JLRTB02027NAS3

**TECHNICAL BULLETIN**

**SUBJECT/CONCERN:**'Coolant Level Low' Message Displayed On The Instrument Panel Cluster (IPC)

Flexing of the auxiliary radiator assembly within the mounting structure is causing cracking, resulting in an engine coolant leak.

E260482

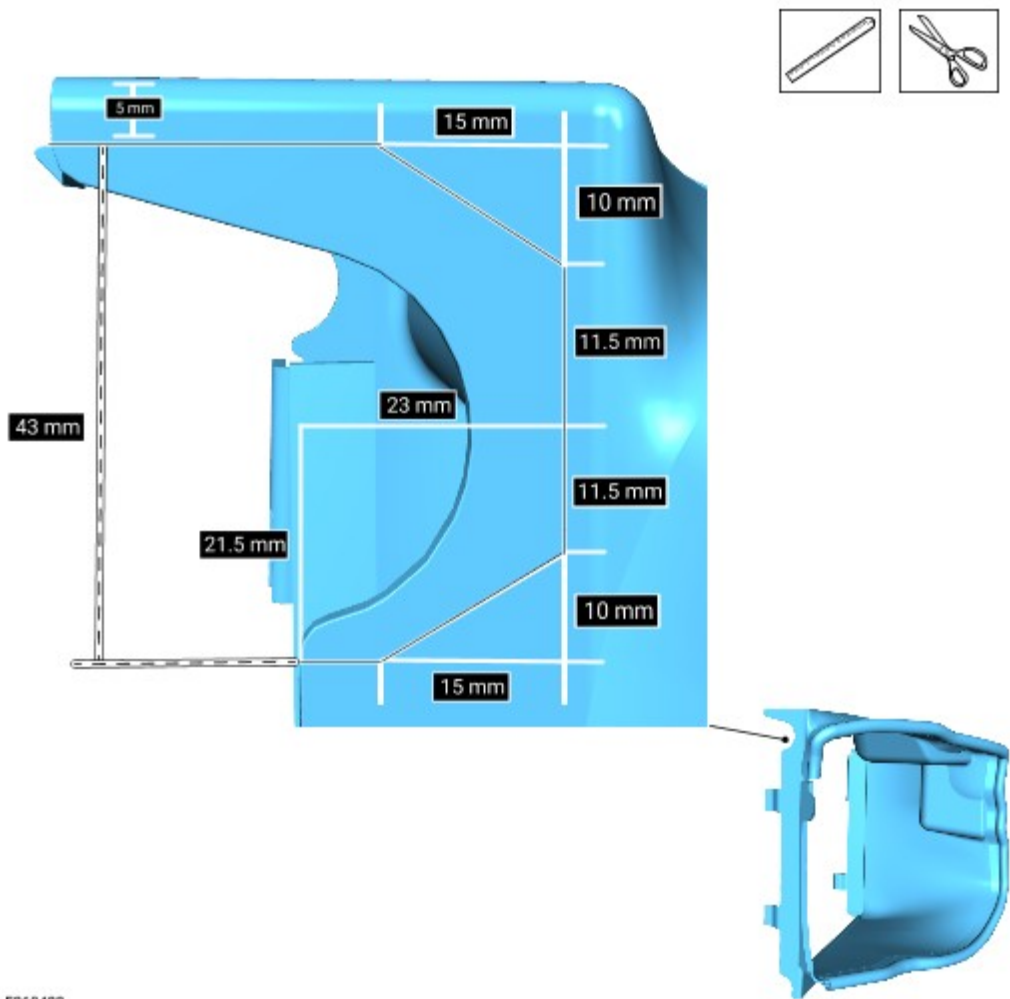
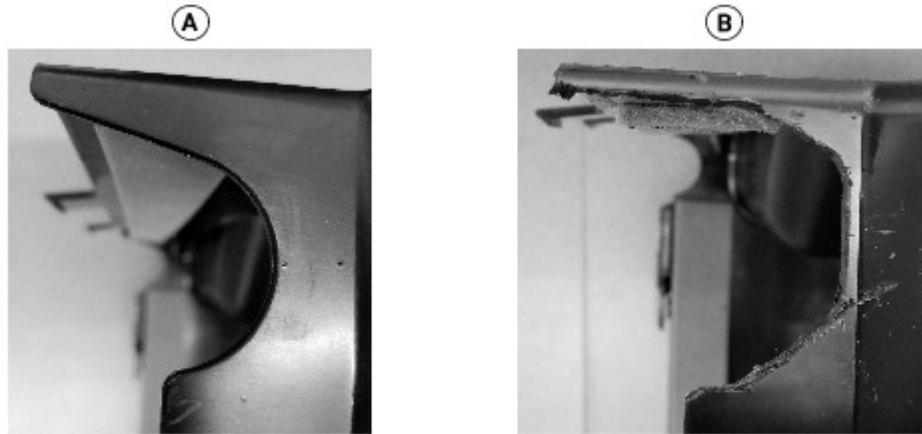
Modify the auxiliary radiator duct using the measurements illustrated as a guide. Step 4 shows a 'before' image and an 'after' to also be referenced.

The illustration marked 'A' shows an image of the auxiliary radiator duct before completing the modification in step 3.

- The illustration marked 'B' shows an image of the auxiliary radiator duct after completing the modification in step 3.

E261711

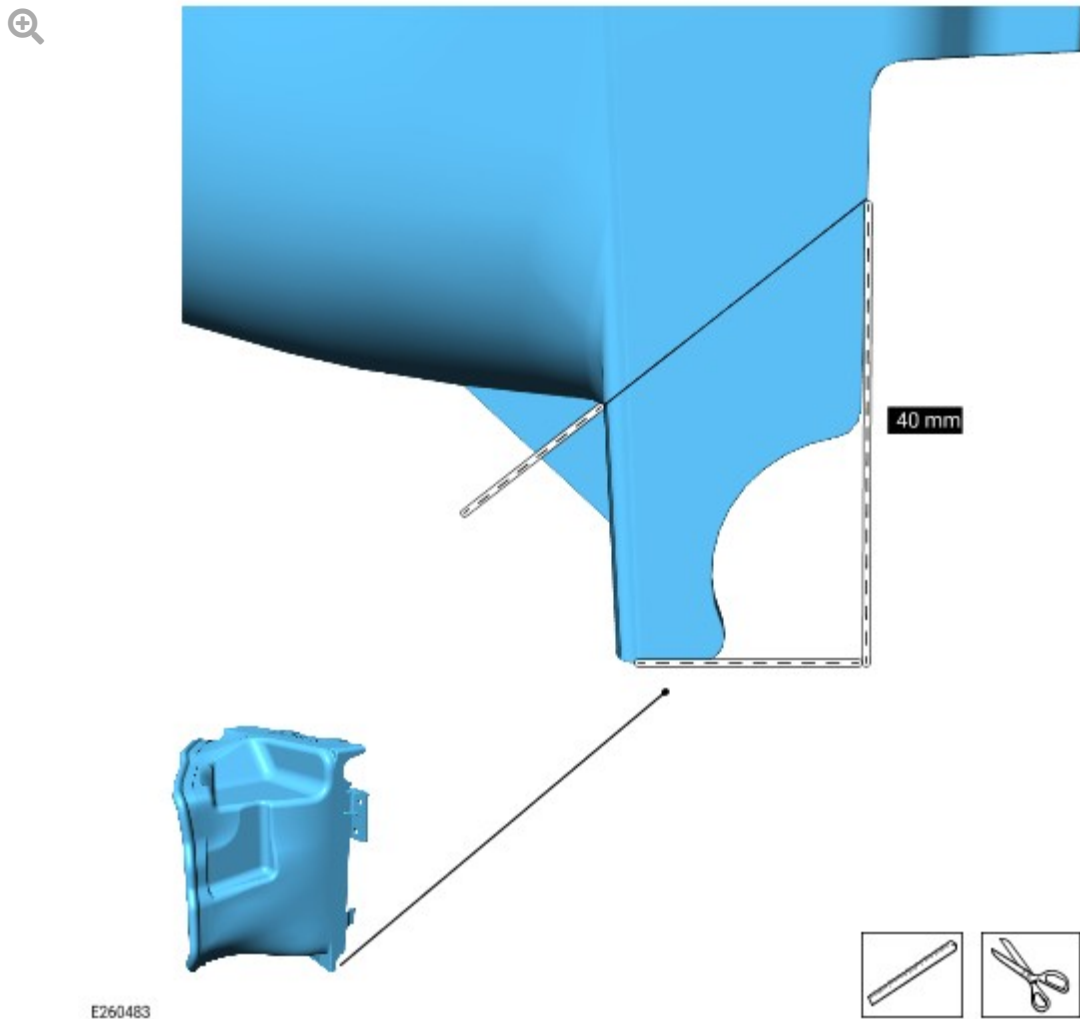
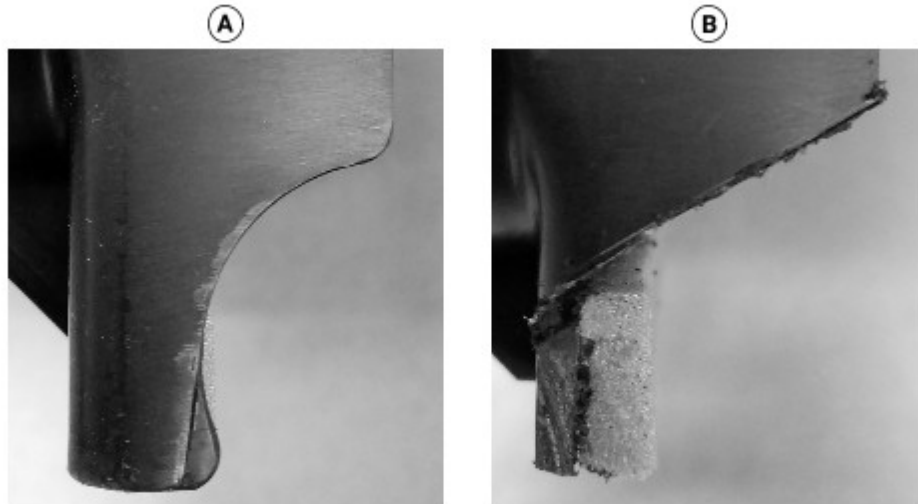
Modify the auxiliary radiator duct using the measurement illustrated as a guide. Step 6 shows a 'before' image and an 'after' to also be referenced.

The illustration marked 'A' shows an image of the auxiliary radiator duct before completing the modification in step 5.

- The illustration marked 'B' shows an image of the auxiliary radiator duct after completing the modification in step 5.

E260481

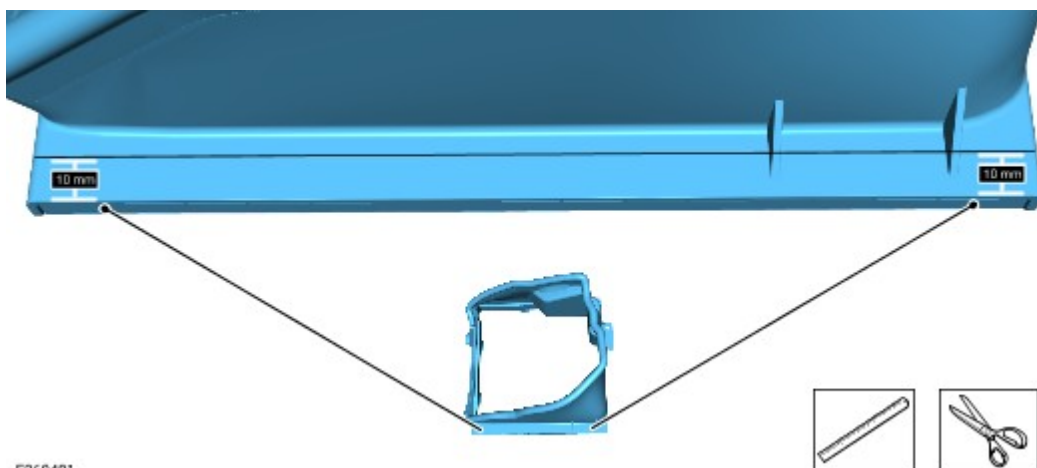
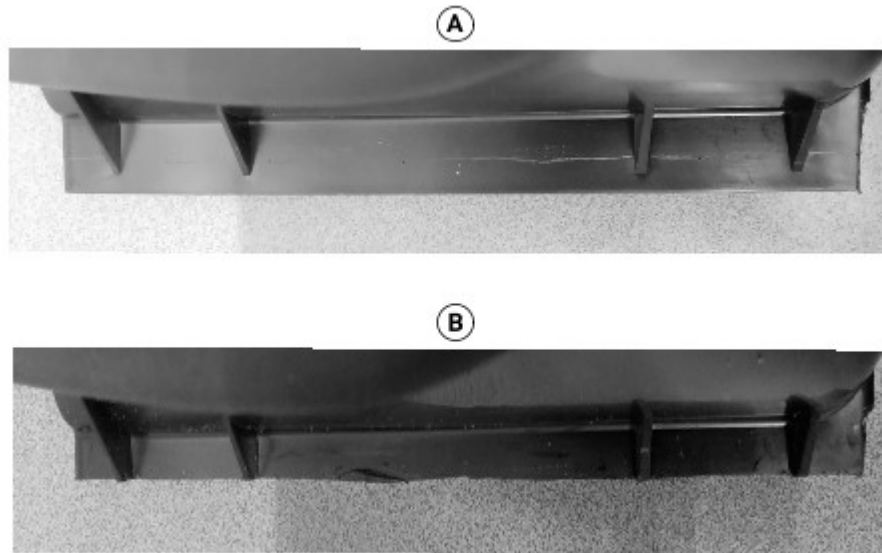
Modify the auxiliary radiator duct using the measurements illustrated as a guide. Step 8 shows a 'before' image and an 'after' to also be referenced.

The illustration marked 'A' shows an image of the auxiliary radiator duct before completing the modification in step 7.

- The illustration marked 'B' shows an image of the auxiliary radiator duct after completing the modification in step 7.
